Road & Bridge Design Publications

Monthly Update – January 2022

Revisions for the month of **January** are listed and displayed below and will be included in projects submitted for the **May** letting.

R-43-J

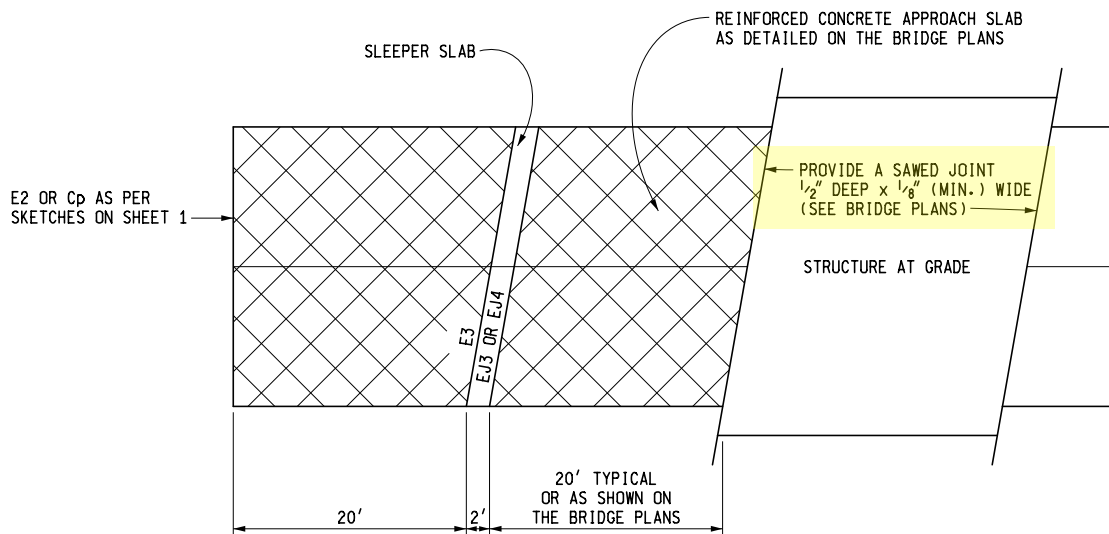
R-43-J: Location of Transverse Joints in Plain Concrete Pavement: Revised the width of the sawed joints at the ends of structure from ($\frac{1}{2}$ " x $\frac{1}{4}$ ") to ($\frac{1}{2}$ " x $\frac{1}{8}$ ") and referenced the bridge plans.

R-45-K

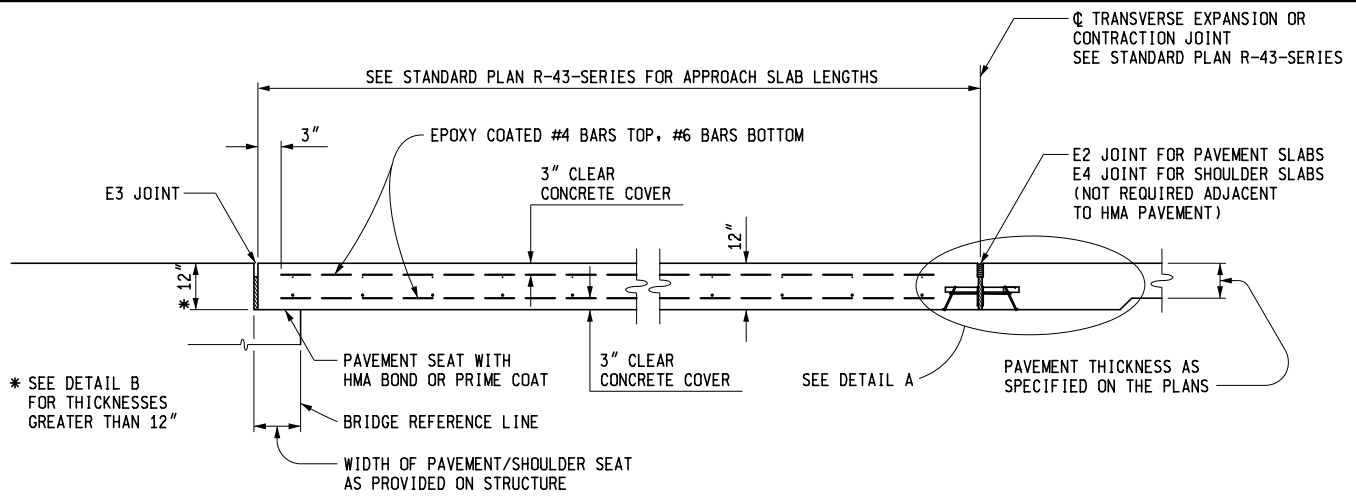
R-45-K: Pavement Reinforcement for Bridge Approach: On sheet one, added an offset from the edge of reinforcement to the edge of slab when the slab is adjacent to HMA pavement.

6.05.04D (continued)

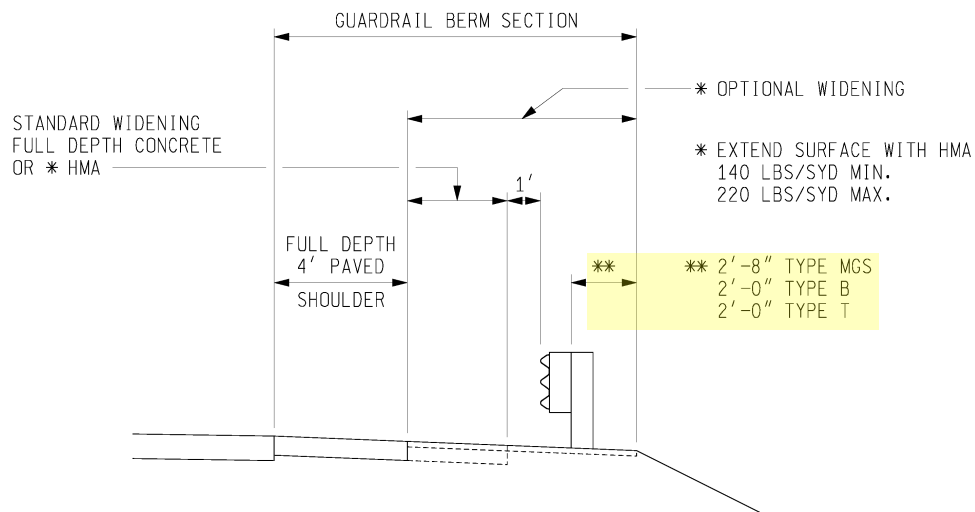
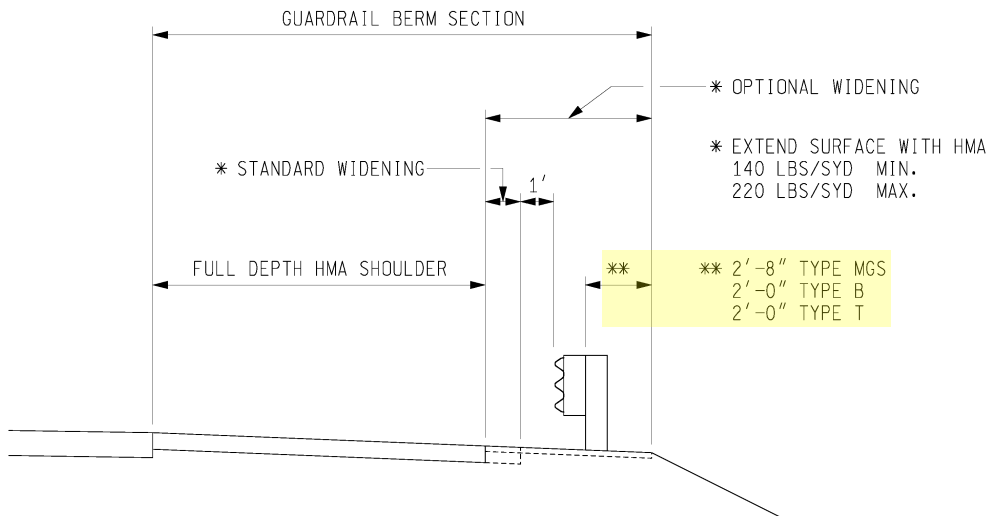
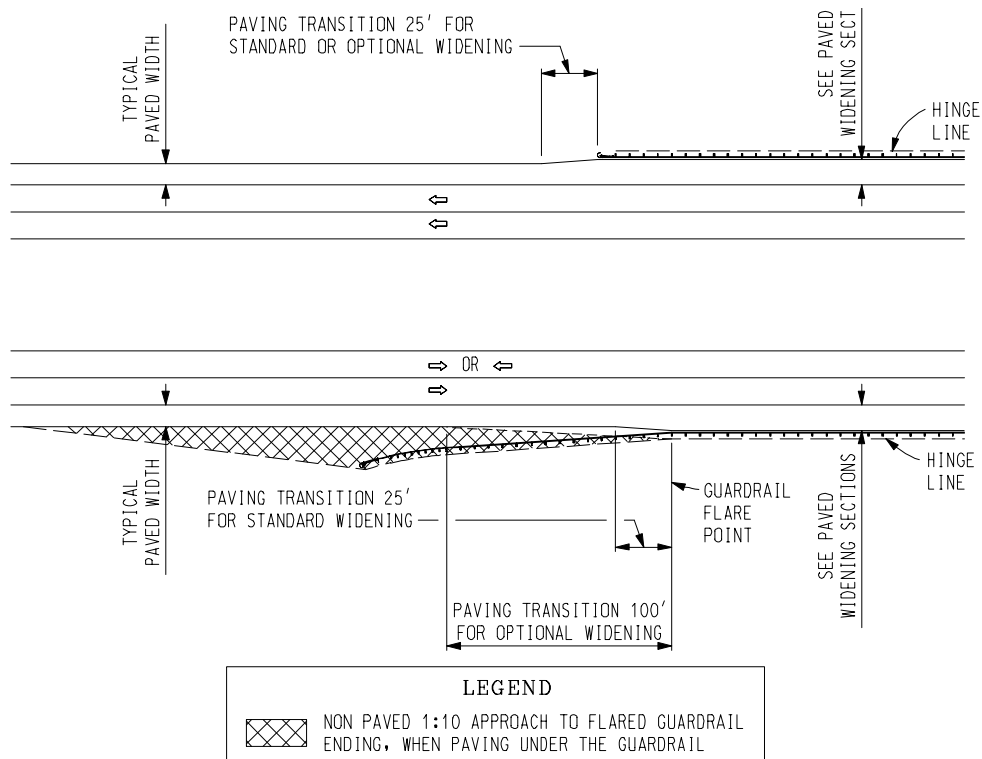
6.05.04D: Widening Shoulder Paving in Guardrail Sections: Added offsets for MGS guardrail to the details.

6.20.04B

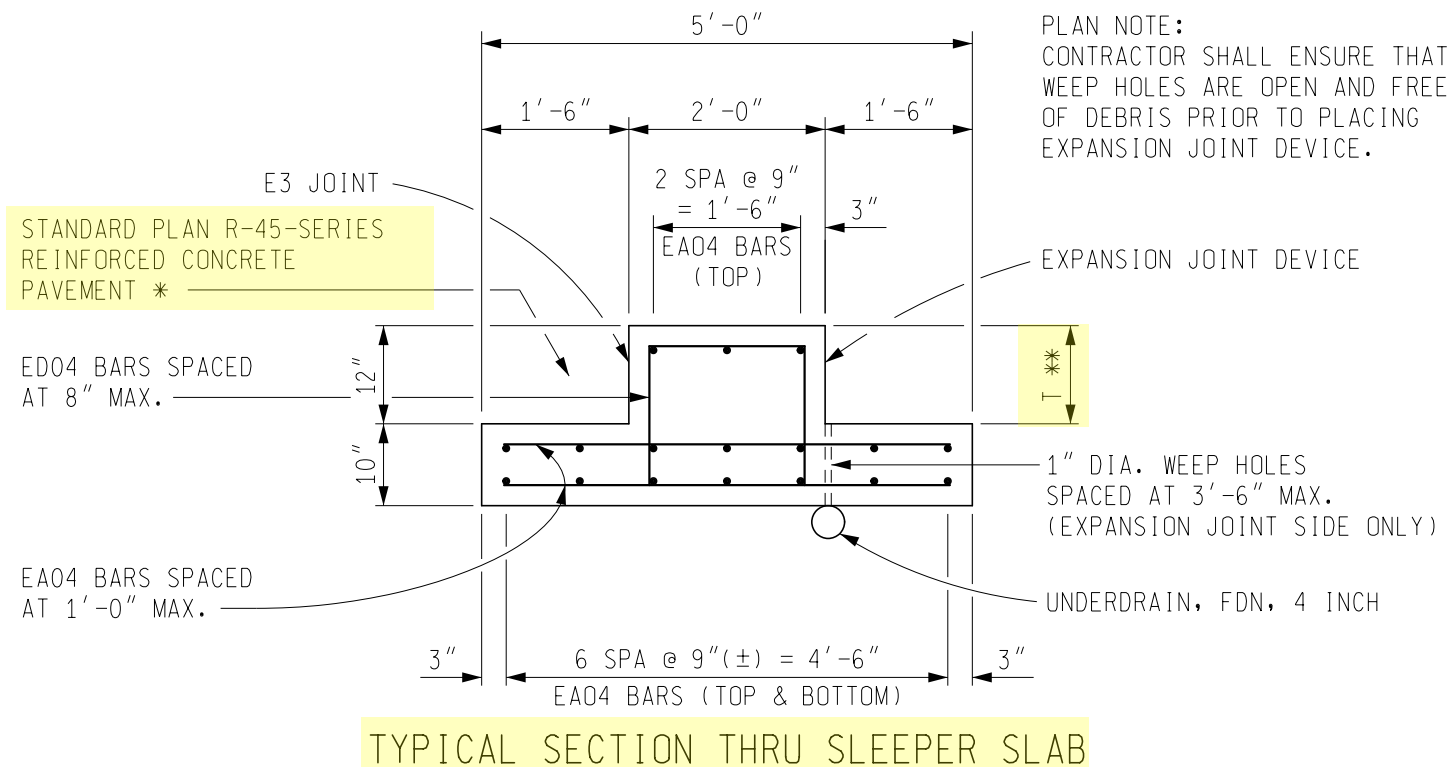
6.20.04, 6.20.04B & 6.20.04C: An inverted “T” sleeper slab will be used with all integral and semi-integral bridges, regardless of road approach pavement type. On the road side of the inverted “T” sleeper slab stub, a Standard Plan R-45-Series pavement will be used and the joint at the far end of the slab will be made perpendicular to the roadway centerline (no skew) (See Standard Plan R-43-Series). Bridge approach slab reinforcement has been updated to smaller #4 bars with at tighter spacing. Changes to bridge approach slab are a complete redesign. Dependent backwalls will have a 9” pavement seat and the approach slab will be 12” minimum thickness. Bars are lapped or developed from bridge deck to approach slab verses the continuation of deck reinforcement. Polyethylene(2 layers) will be used as before but extend 2” onto the top of the backwall. Also updated pay item. On Guide 6.20.04, the highlight to the very right of the page deals with epoxy coated reinforcement for box beams and is related to previous month’s update.
